[11] **Patent Number: Des. 417,632**

[54] **MASONRY FIXTURES**

UNITED STATES PATENT AND TRADEMARK OFFICE
CERTIFICATE OF CORRECTION

PATENT : Des. 417,632

FIG. 7

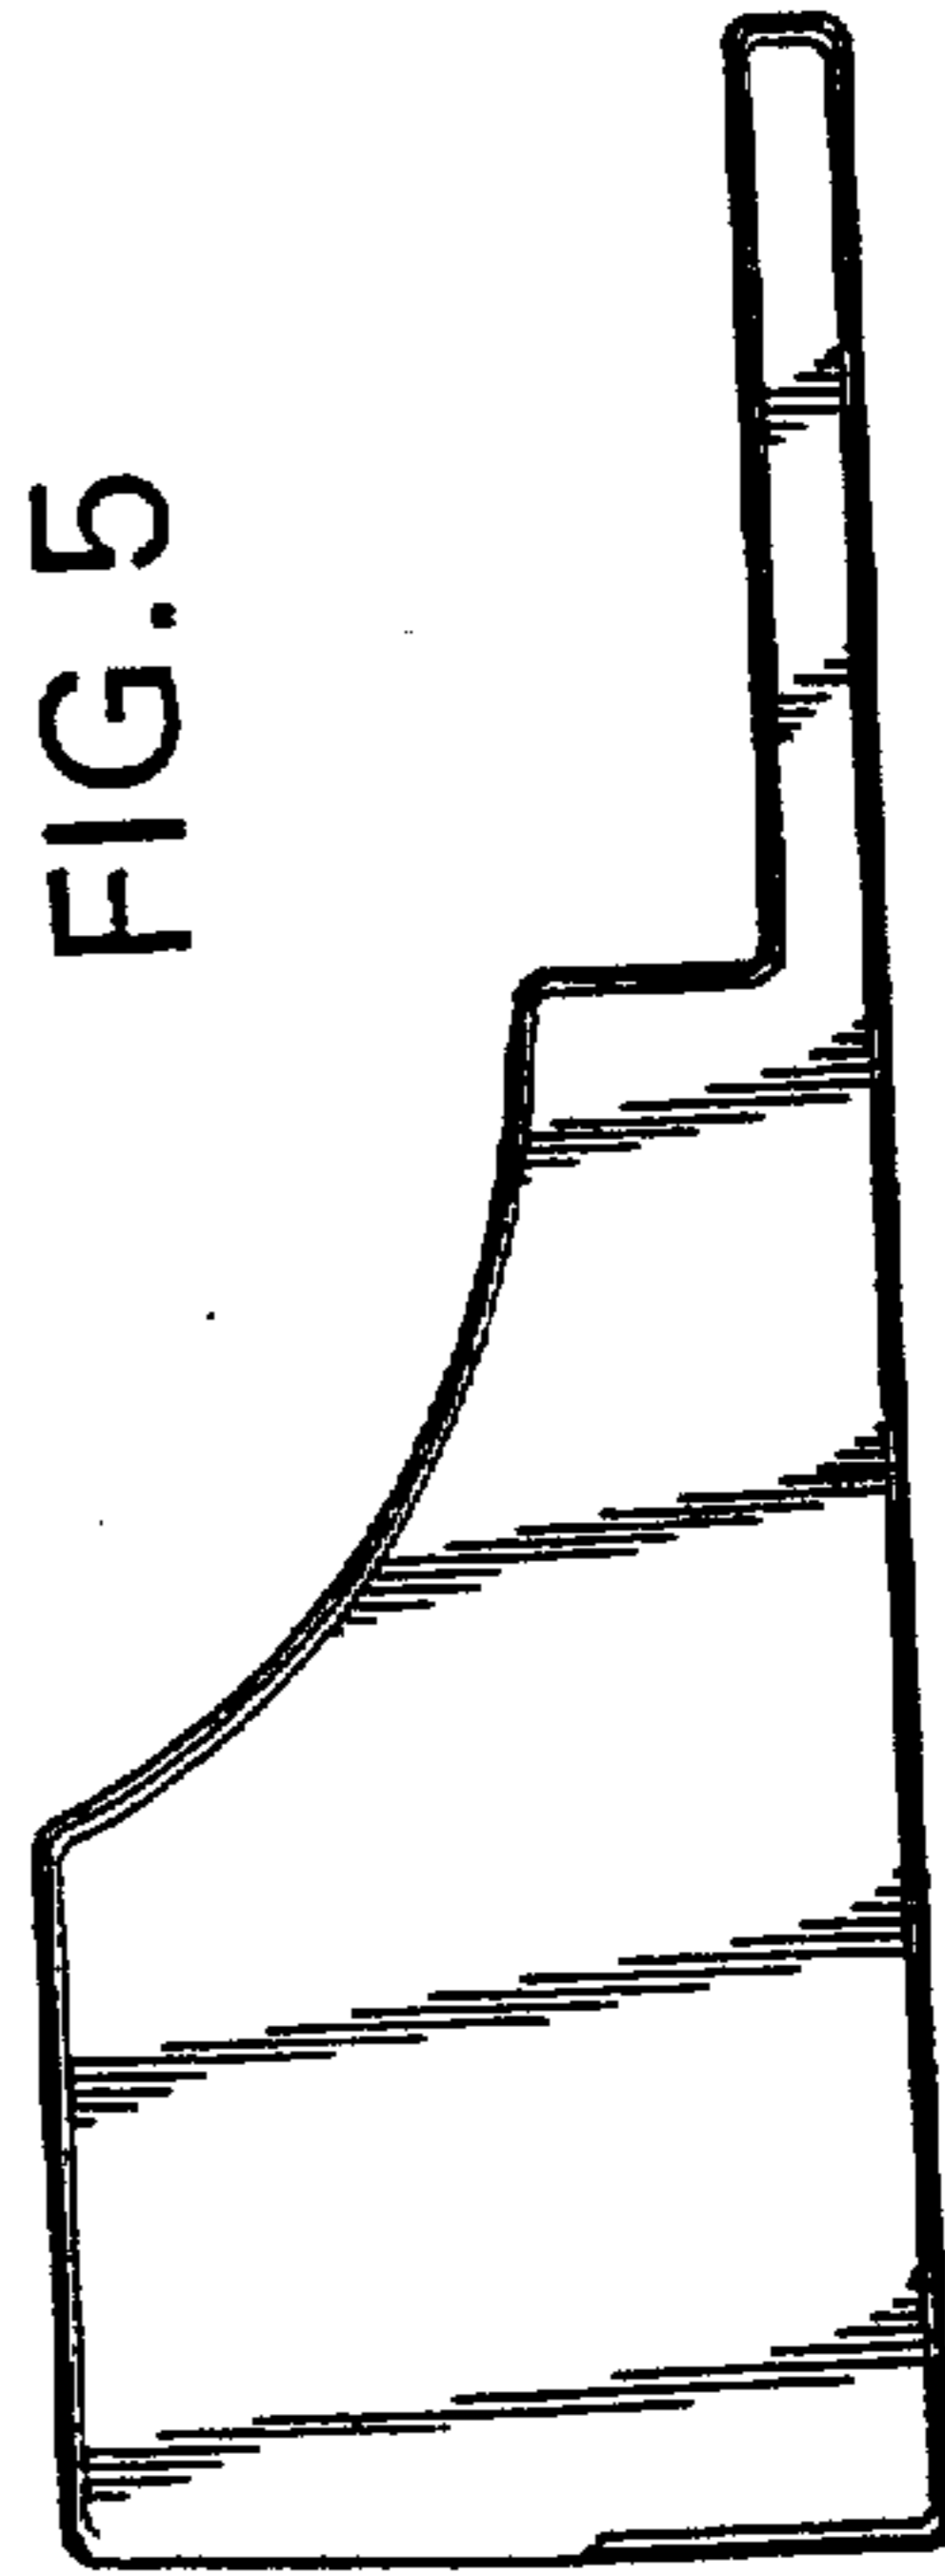
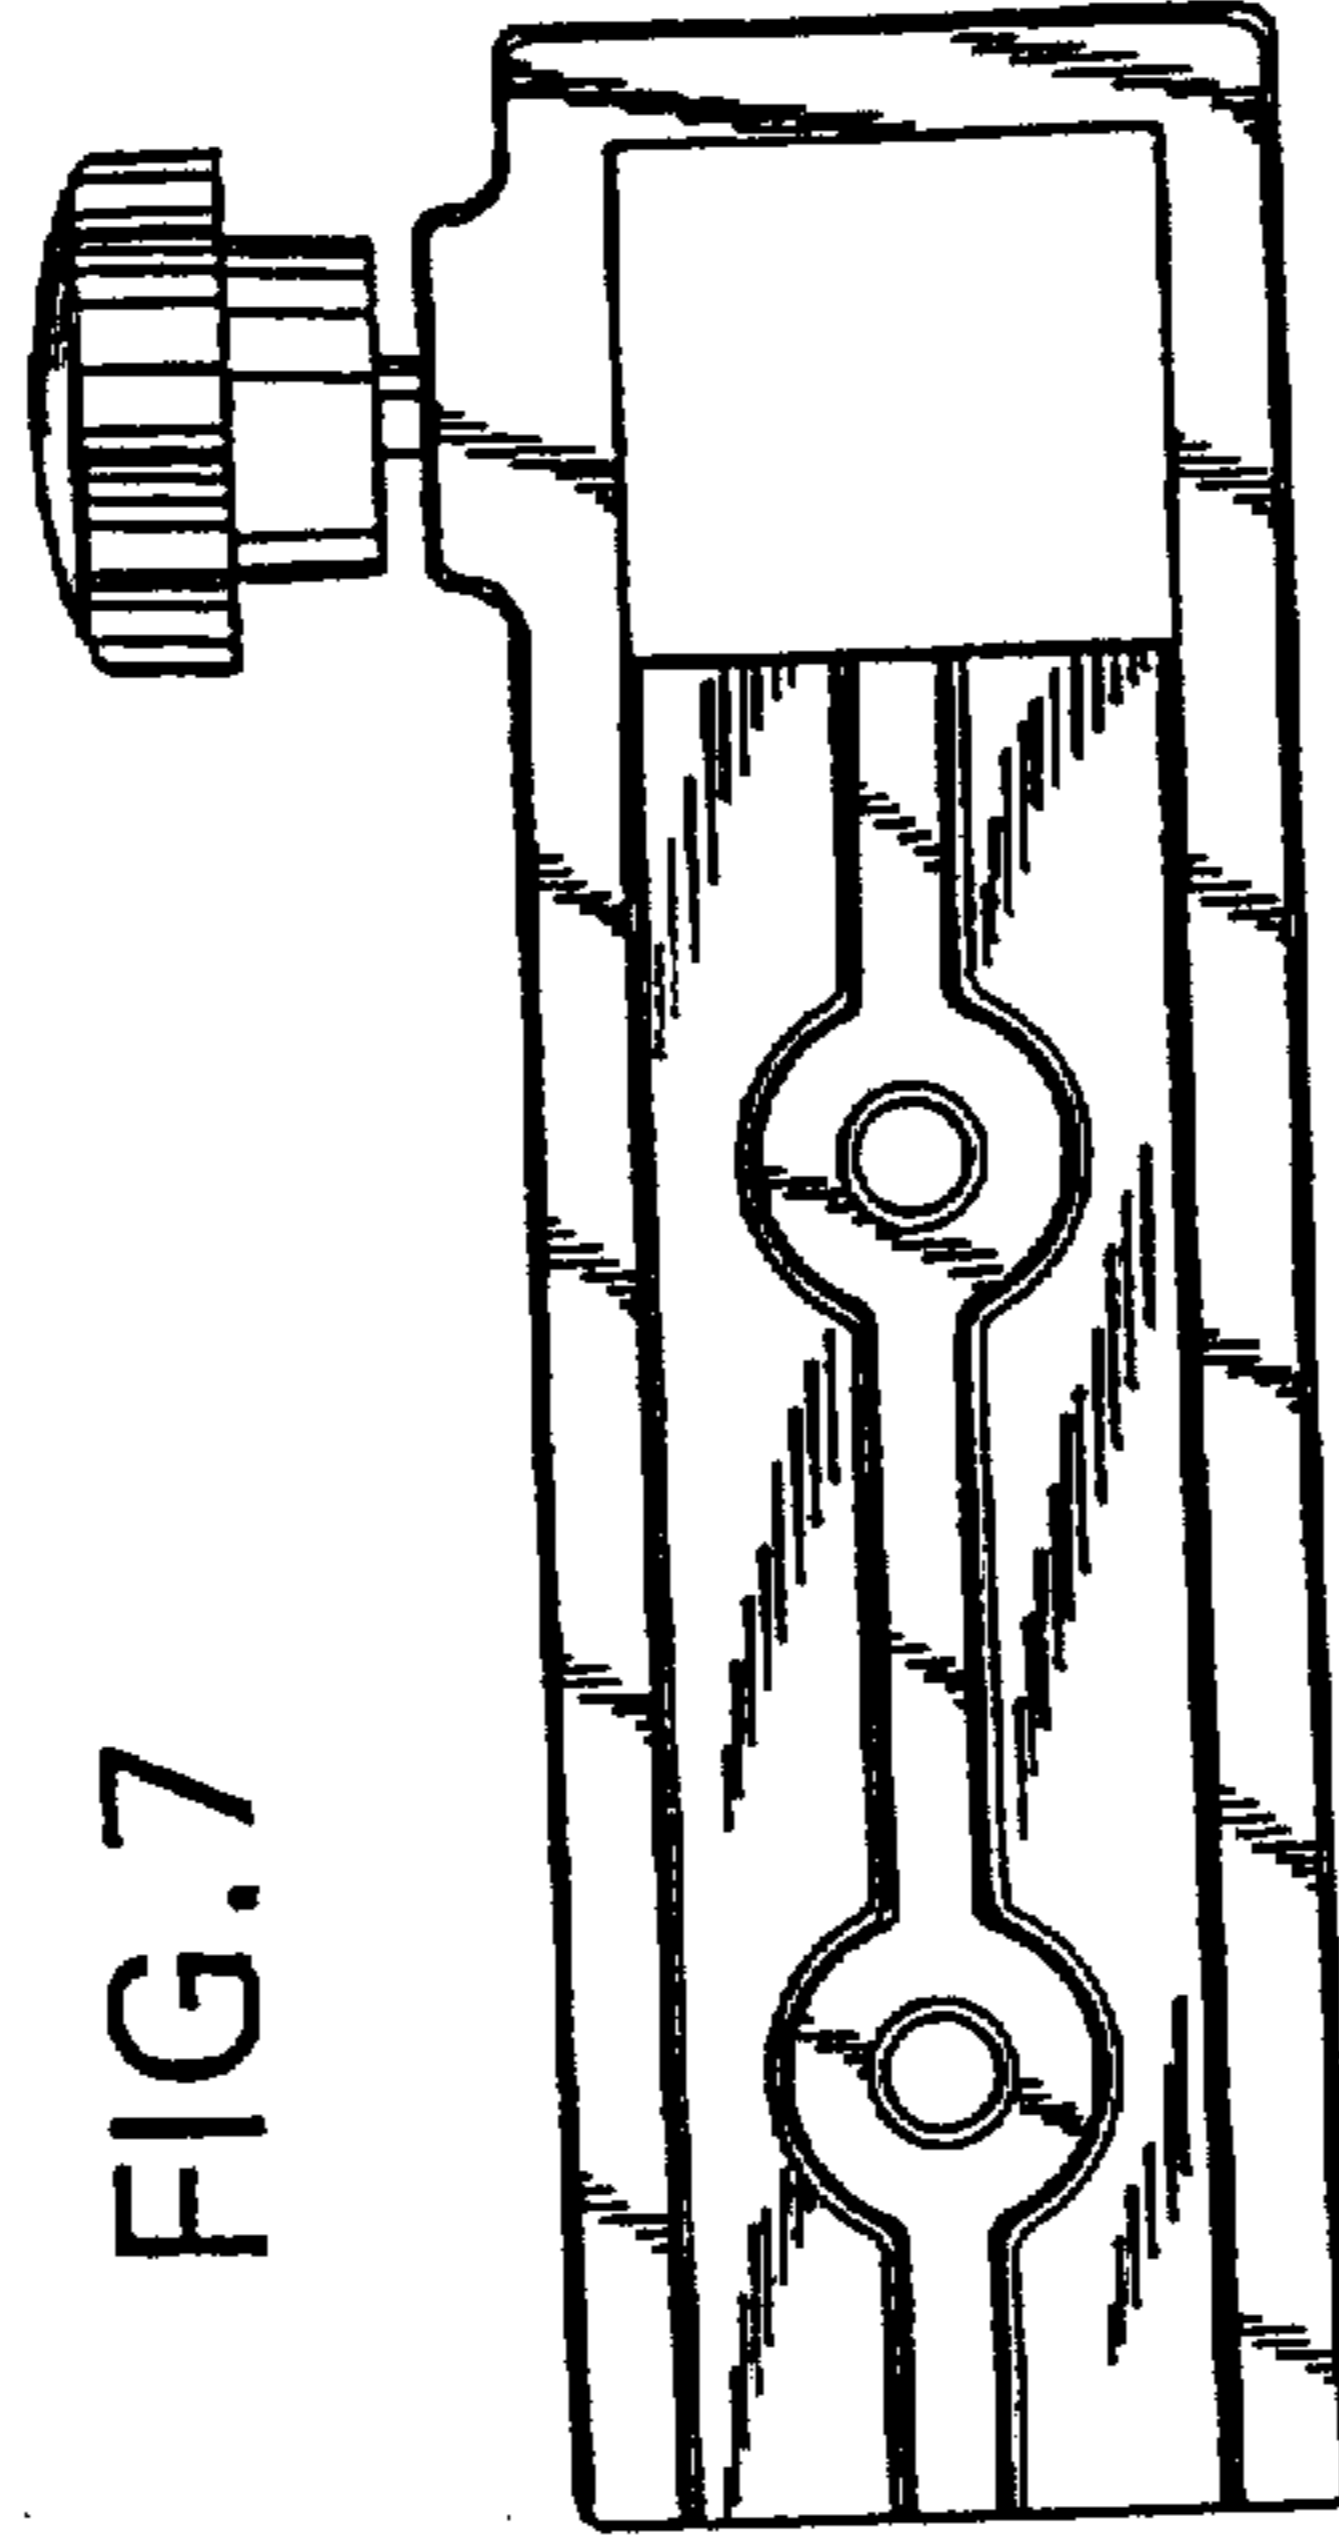
In the drawings, sheets 1 and 2, consisting of Figs. 1-7 should be deleted to be replaced with sheets 1 and 2, consisting of Figs. 1-7, as shown on the attached pages.
